CITY OF PORTLAND, OREGON

Staff Presentation to the
Portland Design Commission

LU 15-129978 DZM AD
Portland State University
School of Business Administration

DAR – January 15, 2015
LU Hearing #1 – May 21, 2015

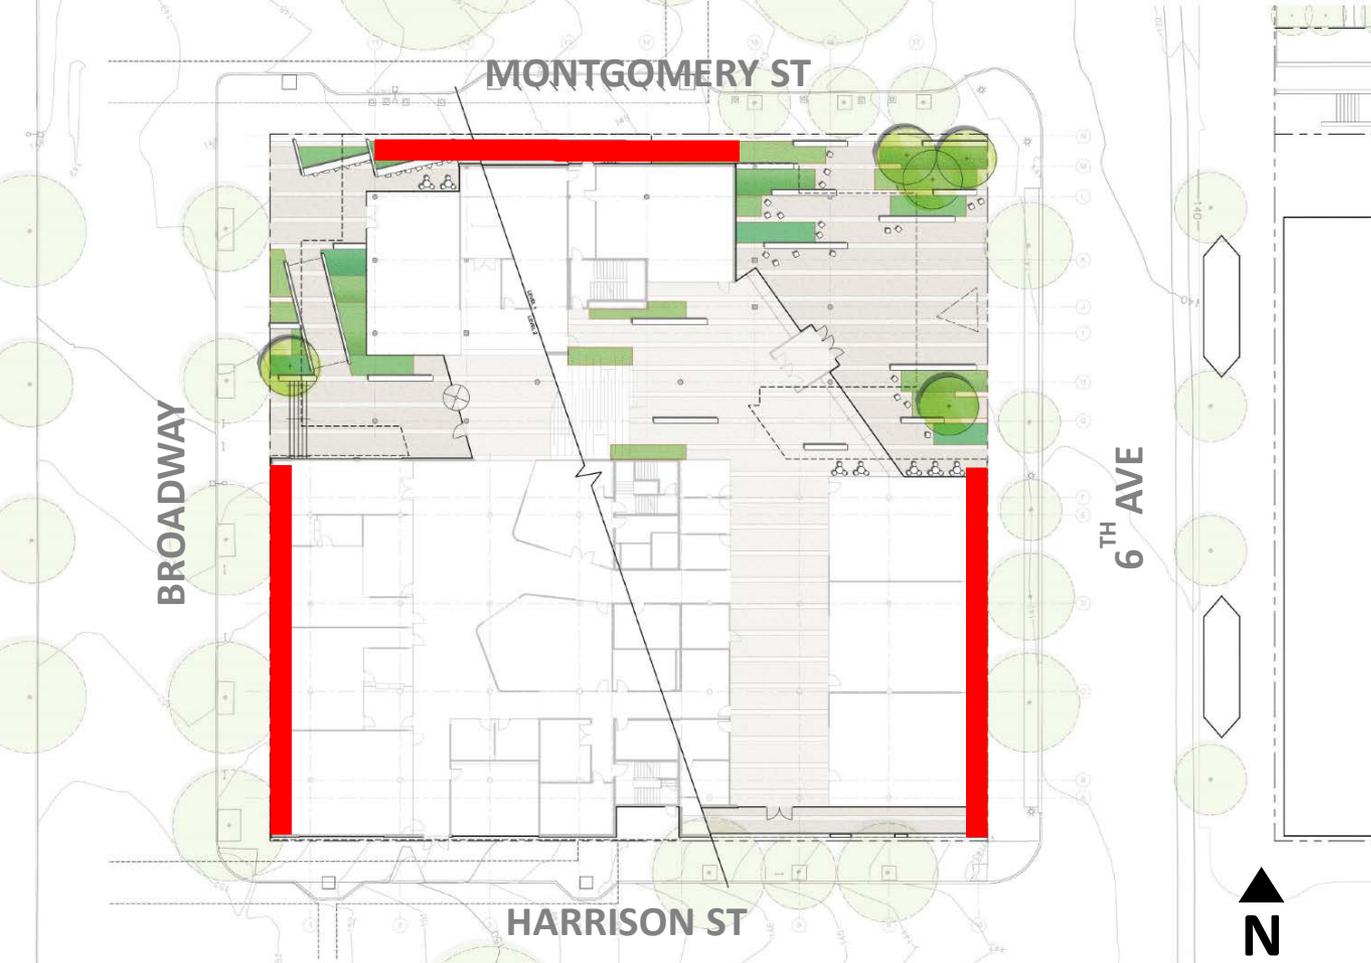
Main entrance must be within 25' of SW 6th Ave (Transit St)

Main entrance proposed to be approximately 33' from SW 6th Ave

STAFF SUPPORTS – Give back = plaza (Better meets: A8, B1, B4, B5).

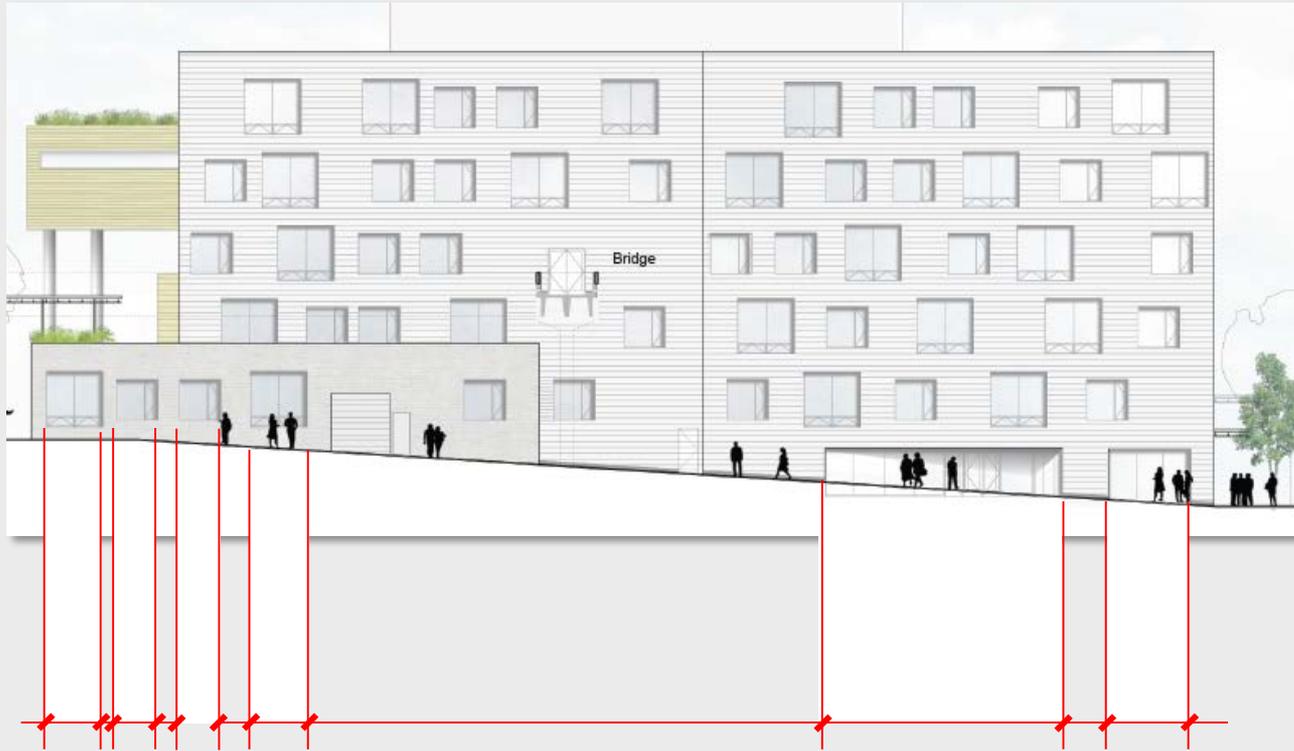
Buildings must be within 12' of property line for 75% of frontage.

SW 6th Ave & Broadway frontages: 52%
 SW Montgomery St: 35%

STAFF SUPPORTS – Give back = plaza (Better meets: A8, B1, B4, B5).

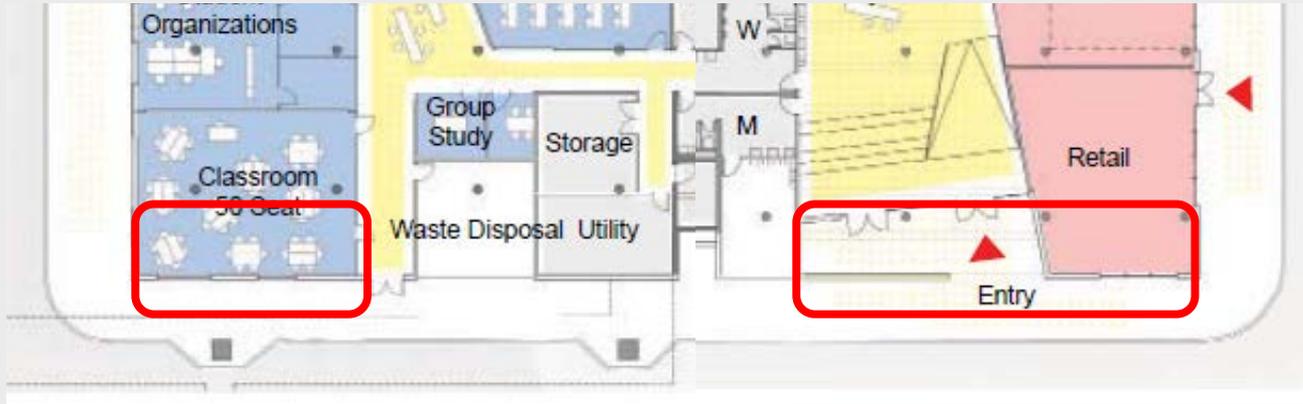
Windows must extend 50% of length and 25% of area on ground floor walls.

SW Harrison St: 50% length (up from 44%, 12') (**meets**); 28% area (**meets**)

EXISTING ON-STREET LOADING

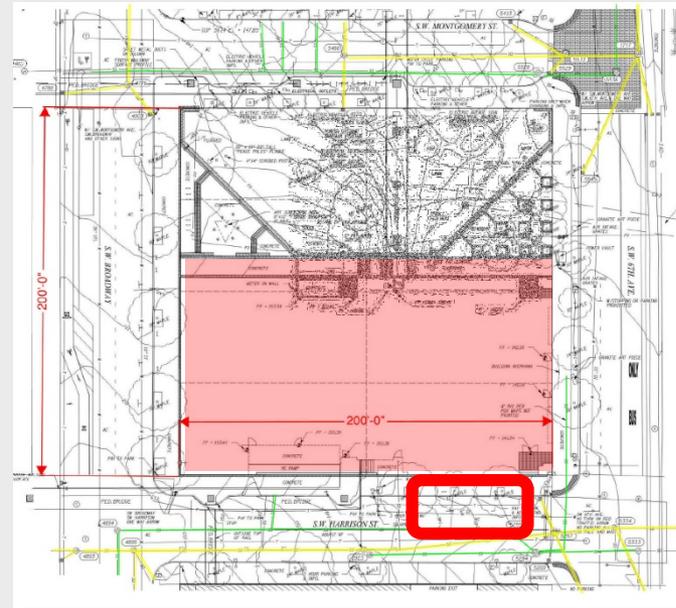
Ground floor active use must be 50% of length on all street frontages.

SW Harrison: 60%. (**meets**)

PSU CENTRALIZED LOADING

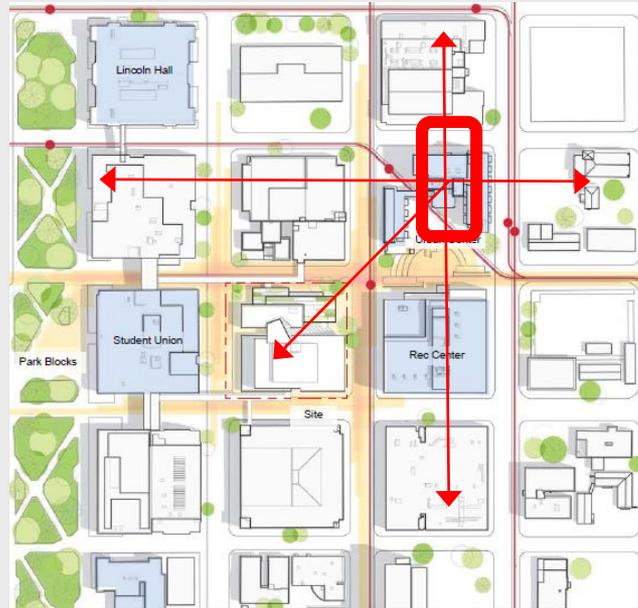
One (1) Standard A Loading Space

None

STAFF SUPPORTS – *Integrated loading strategy with PSU Campus.*
